WALDORF TOWERS HOTEL

Issue: Providing an accessible route to a public entrance.

**REQUEST FOR WAIVER FROM ACCESSIBILITY REQUIREMENTS
OF CHAPTER 553, PART V, FLORIDA STATUTES**

Request for Waiver from Accessibility Requirements of Chapter 553, Part V, Florida Statutes

A.SK-01

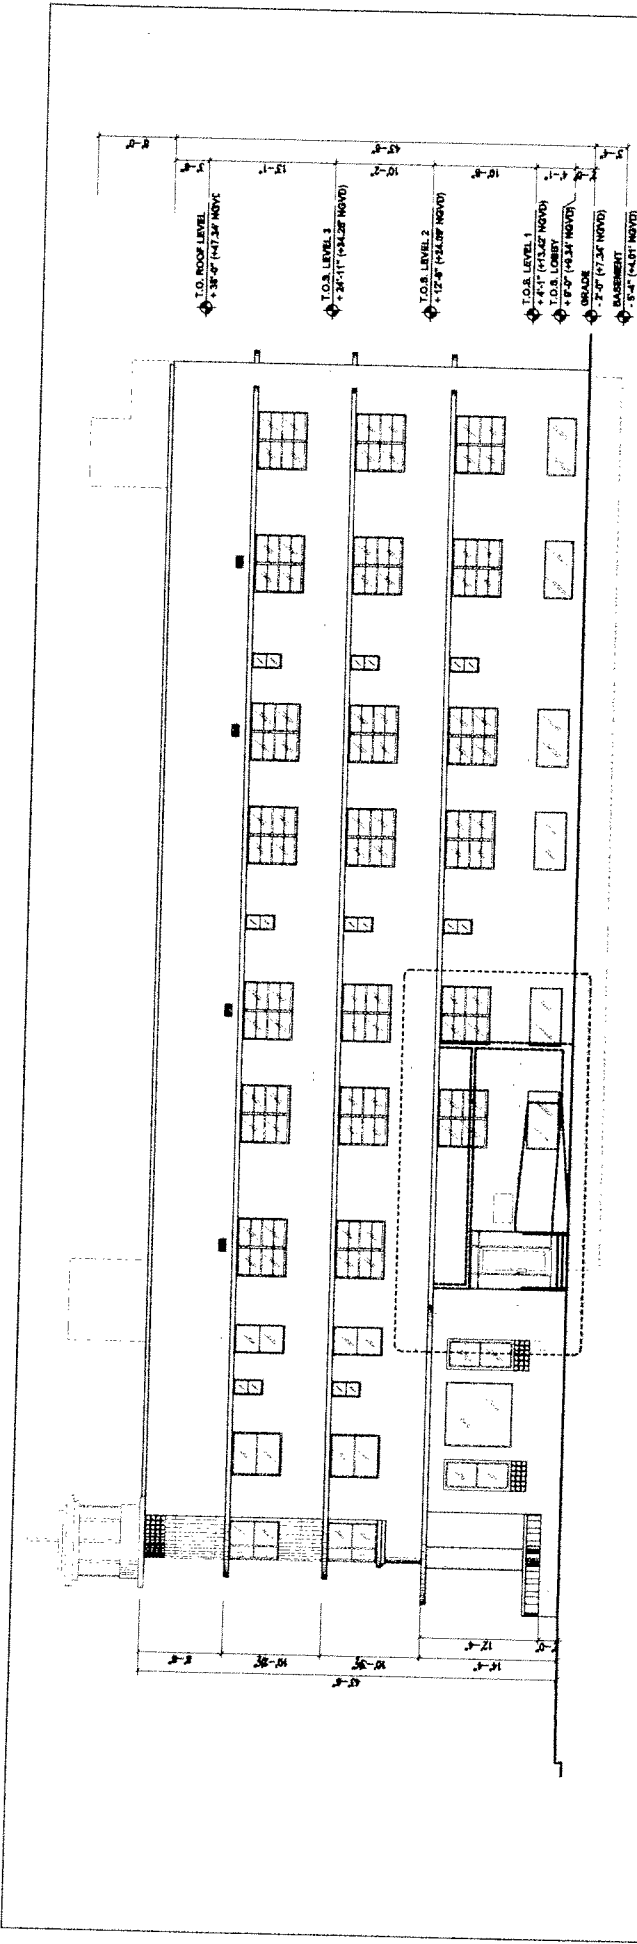
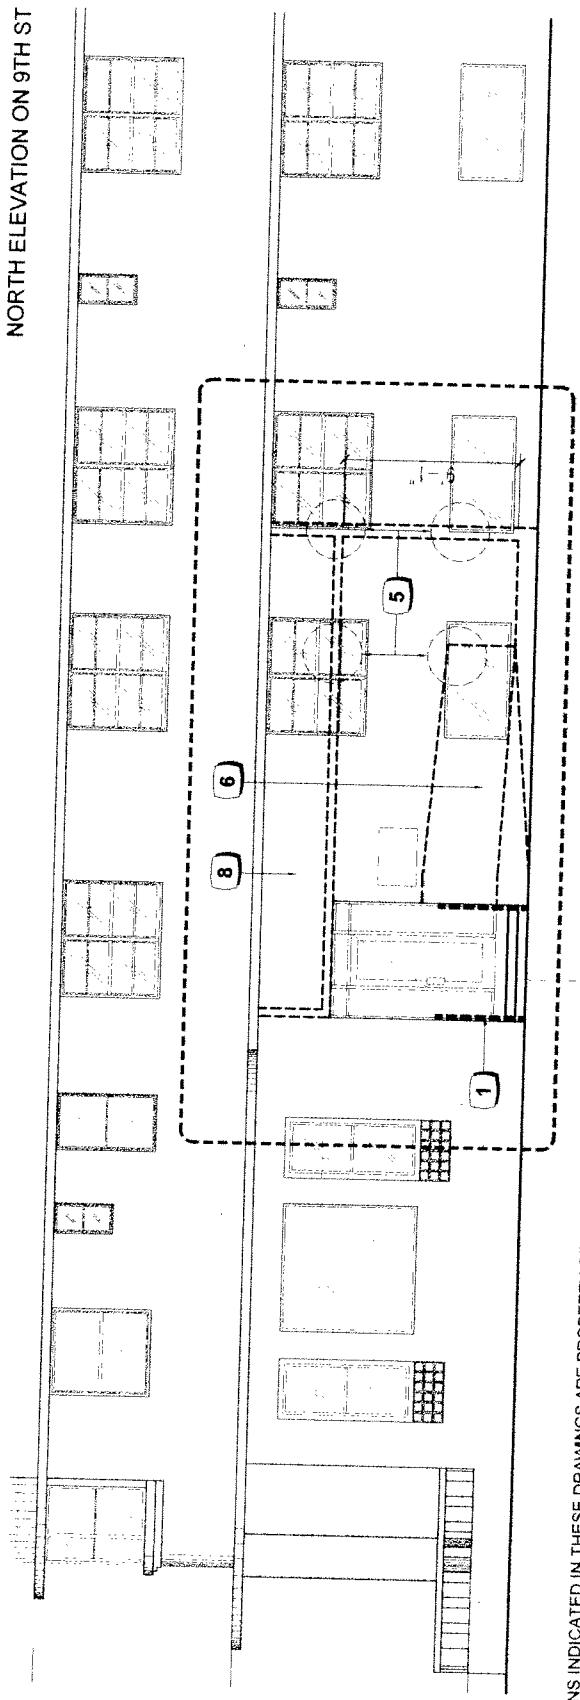
The following is an analysis to provide an accessible route with the insertion of an ADA ramp at the North Entrance of the Building on 9th Street. A chairlift would have a similar scenario. An accessible route at this Entrance would not be readily-achievable or technically -feasible due to the following reasons: (Please refer to A.SK-01 & 02 for the reference numbers below)

- 1.** Reconfiguration of the existing steps at this Entrance is required to incorporate an ADA ramp. The proposed three steps to access Market and Hotel Lobby are required to have handrails as per FBC 2007, Section 11-4.9.4. The required handrails represent a conflict with the proposed ramp landings as per FBC 2007, Section 11-4.8.4.(1)-(3).

- 2.** Access door to Lobby does not comply with required maneuvering clearances as per FBC 11-4.13.6. Figure 25 (a).
- 3.** A sliding door is proposed to close the Market during non operational hours. It will remain open during the day in order not to conflict with the mean of egress.

- 4.** There is a concern that the proposed ramp would create a dark corner that could potentially be haunted by homeless to sleep in or use it as a restroom or for delinquent activities especially during no operational hours. To prevent this situation a door is required to enclose this space. Ideally the door should be located prior to the ramp's bottom landing. However due to the proposed configuration and limited available space, the only possible location to provide a door is on the face of the North Façade (9th Street). A suggestion for a roll up door at this location was presented to City of Miami Beach Zoning Department as shown on # 4 on A.SK-01, but it was rejected because roll up doors or any other type of doors on Historic Façades, destroy the Historic significance of the Building and are not allowable. Not properly enclosing this space can become a serious concern for the City of Miami Beach and will not be acceptable.

- 5.** The proposed ramp conflicts with four existing Historic windows on the North Façade (9th Street), two at the Basement Level; and two at the First Level. This is a significant impact as it destroys the rhythm of the windows, aligned from Basement Level all the way up to the 3rd Level, in the Historic Façade. Please refer to elevations.

- 6.** The proposed ramp may require a separate foundation which can potentially impact the integrity of the existing structure. The required handrail around the perimeter of the ramp may demand to further reinforce the exterior wall affecting structurally the Historic North Façade (9th Street).

- 7.** The proposed ramp also represents the loss of valuable rentable space in the Market located at the Basement Level.
- 8.** The existing finish floor slab at the First Level will need to be cut to allow for the proposed ramp required headroom, thus eliminating two Guest Rooms which are proposed to be recovered from the original hotel design. This is a significant financial impact for the Hotel Owner.

A.SK-03

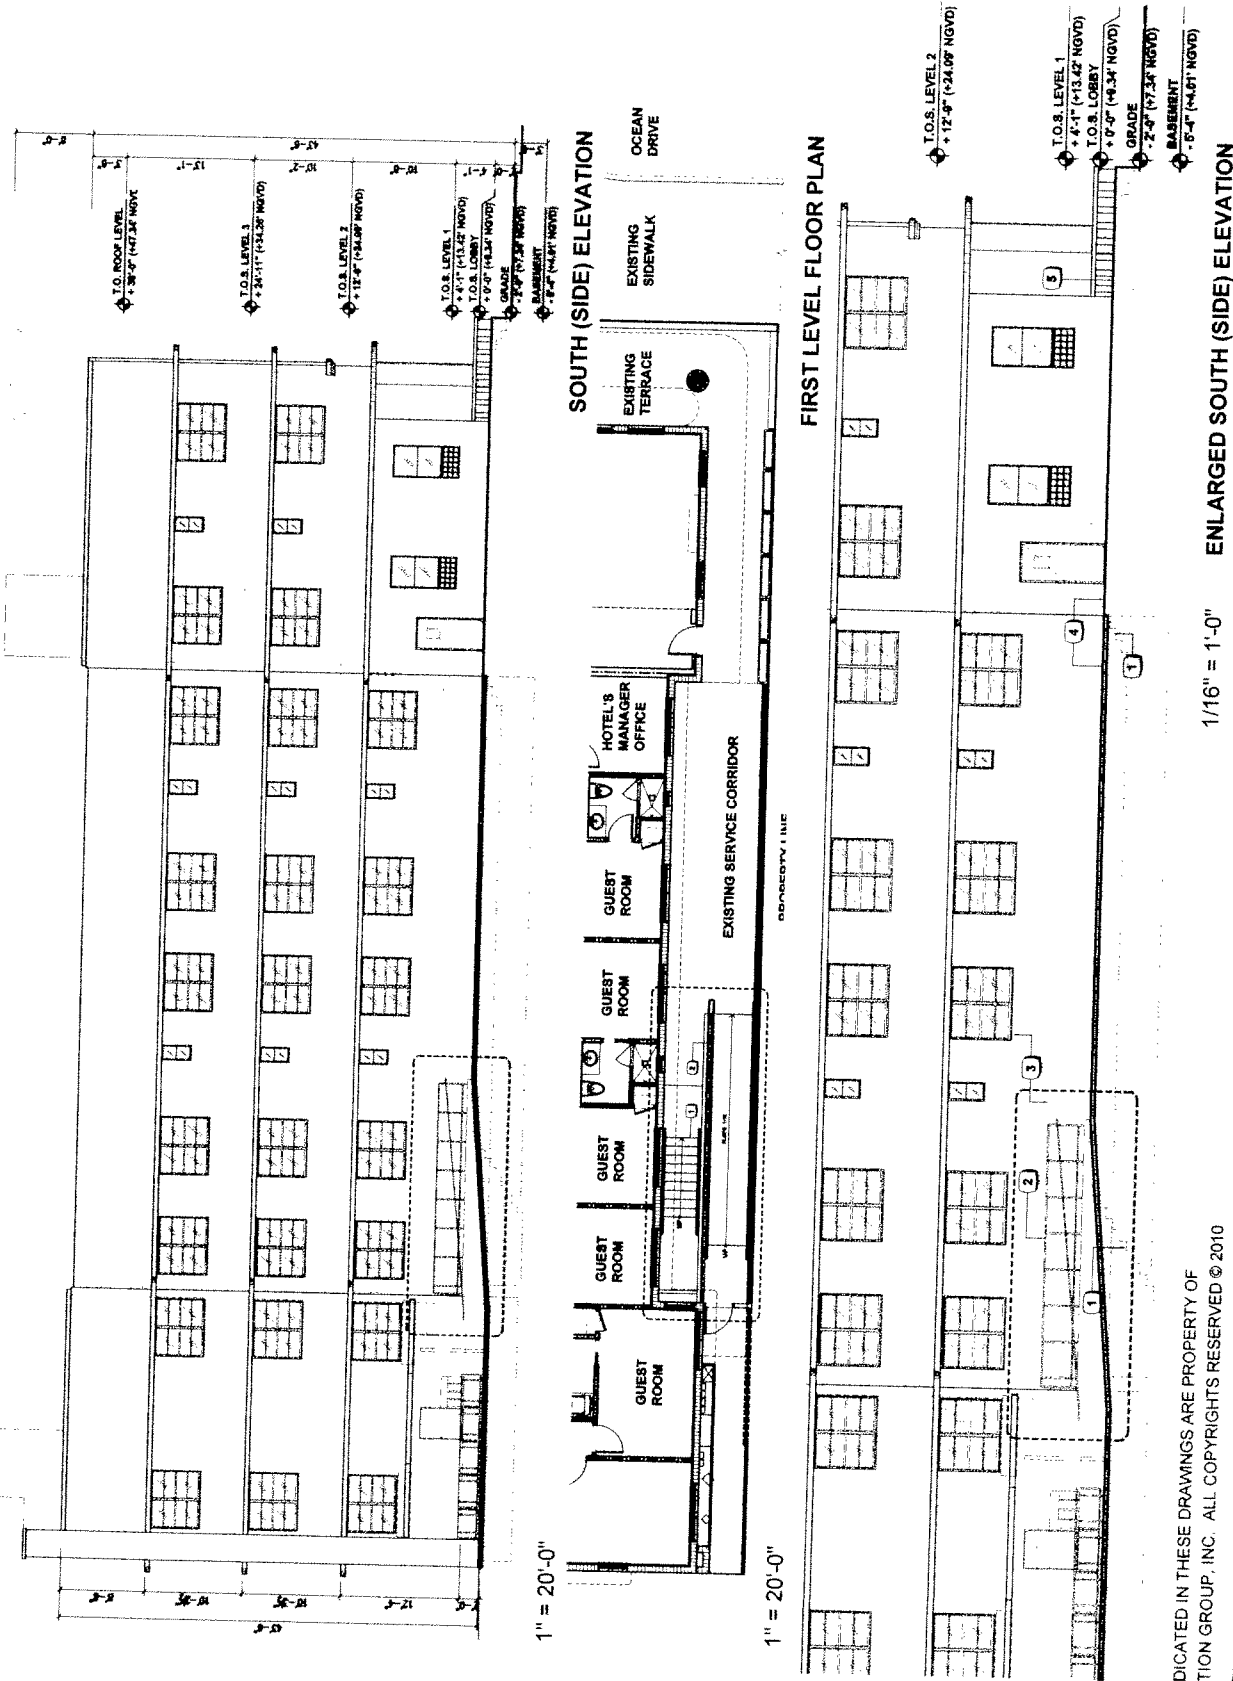
The following is an analysis to provide an accessible route at the West Side of the Building (Service Corridor). An accessible route at this Entrance is feasible and does not destroy the Historic significance of the building due to the following reasons:

1. The existing steps to the Kitchen Entrance (Half Level Down) were reconfigured to allow for more room to add an accessible ramp next to them. Additionally, these steps were combined with the steps coming from the front terrace (East Side) to eliminate the difference in levels.

2. The proposed ramp complies with FBC 2007, Section 11-4.8.
3. The proposed ramp does not affect the Historic South Façade as the reconfiguration of Kitchen Entrance steps and addition of the ramp do not impact significantly the building structure neither they conflict with any exiting windows on this Façade.

- 4-5 The proposed ramp connects the West Side Entrance to the Hotel Lobby through the South service corridor and front terrace (East Side). As part of the proposed design, this Entrance will be improved by providing a new fence, new finish floor, new exterior painting, new decorative lighting and planters along the way which will create a more appealing and welcoming look. A security camera and a ADA doorbell will be provided at the door of the West Entrance to control the access. This ADA doorbell will be connected to the Hotel reception desk and will advise when a Hotel Guest wants to access the Entrance.

According to FBC 2007 Section 11-4.1.7 (2)(b) *Alterations to qualified Historic Buildings and Facilities not subject to Section 106 of the National Historic Preservation Act*: if the state historic preservation officer agrees that compliance with the accessibility requirements for accessible routes (interior & exterior) would threaten or destroy the significance of the Building or Facility, the alternative requirements in FBC 2007, Section 11-4.1.7 (3) may be used. Under the minimum requirements described in this section (b) exception: if it is determinate that no entrance used by the public can comply with Section 11-4.14, than access at any entrance not used by the general public but open (unlocked) with directional signage at the primary entrance may be used. The accessible entrance shall also have a notification system. Where security is a problem, remote monitoring may be used.
